**Application No. : 10/020,544**  
Response filed December 1, 2005  
Responsive to a Notice of Allowance September 7, 2005

### **AMENDMENTS TO THE DRAWINGS**

**Fig. 7 (EXHALATION)**

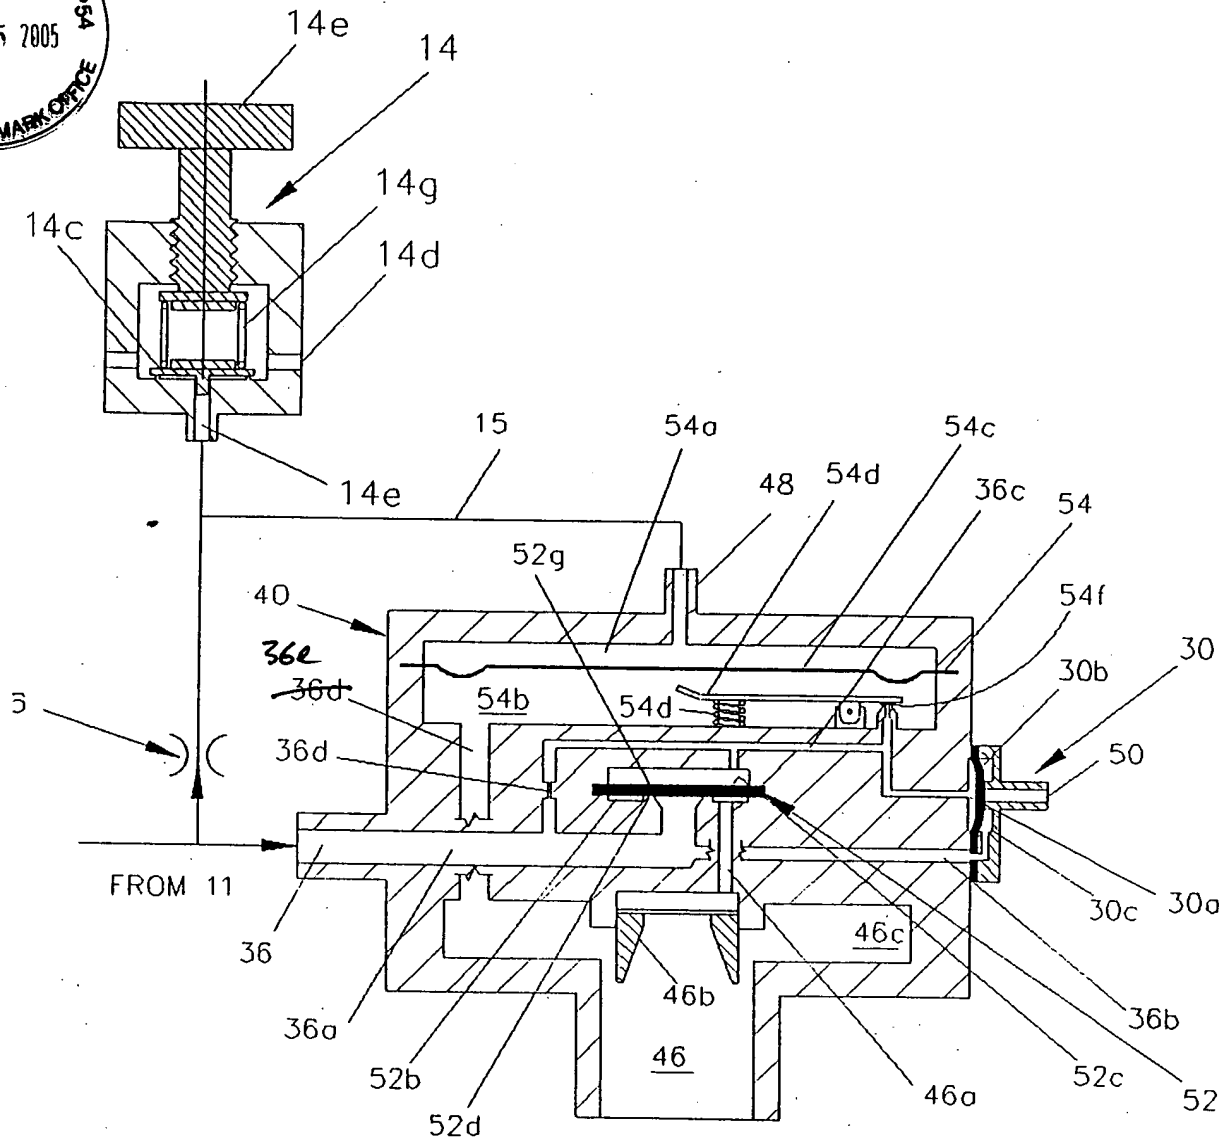
The attached sheet of drawings include changes to FIG. 7. This sheet includes FIG. 7 and replaces the original sheet including FIG. 7. In FIG. 7, the upper 36d reference number is replaced with 36e.

FIG. 7 has been amended according to the Examiner's comments to the Notice of Allowance. One of the "36d" reference numbers has been corrected to read -- 36e --. Support for the amendment is found, for example, in the specification on page 10, lines 19-23 as modified in the Preliminary Amendment filed May 2, 2003, page 4 ("Passageway 36e connects the lower chamber 54b of valve 54 to an outlet chamber 46c of the demand valve, which chamber extends above the outlet port and circumferentially around a nozzle 46b."). No new matter is entered by way of this amendment.
